Product Safety Recall

N202312100 Seat Belt Cable Separation – US Only

Revision: 01

Revision Description: This bulletin has been updated to include the customer letter. Please discard all previous copies of N202312100.

4593189

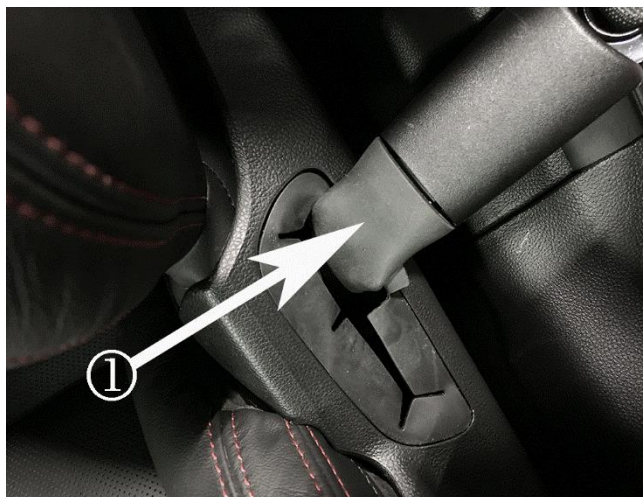
1. Using the seat adjustment switch, move the driver seat as far rearward and downward as possible. The front safety belt cable sleeve (hereinafter, “sleeve”) covers the flexible steel cable that connects the safety belt to the vehicle at the front outside seating position. The sleeve is covered by the seat trim and comes out of the slot on the side of the front seat.

2. Inspect the sleeve for any cuts or cracks. Bend the cable toward the inside and outside of the vehicle and inspect the area near arrows (1) above.

4522272

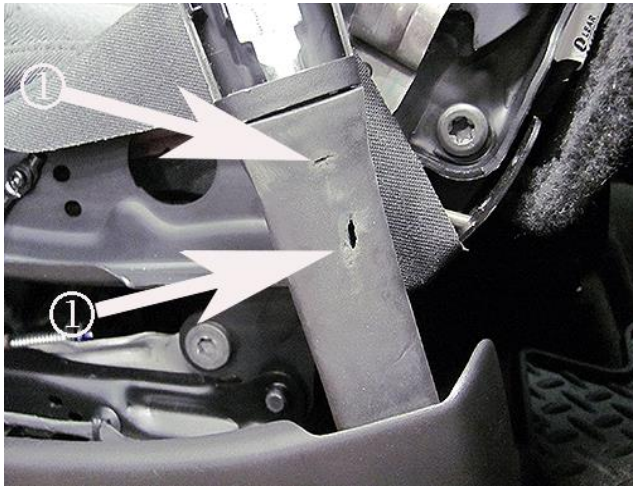
This damage will be in the form of holes (1) or splitting (2).

- If **any damage** is found, replace the tensioner and revised seat trim listed above. Refer to *Front Seat Belt Anchor Plate Tensioner Replacement* in SI.
- If no damage is found, only install the revised seat cushion outer finish cover.
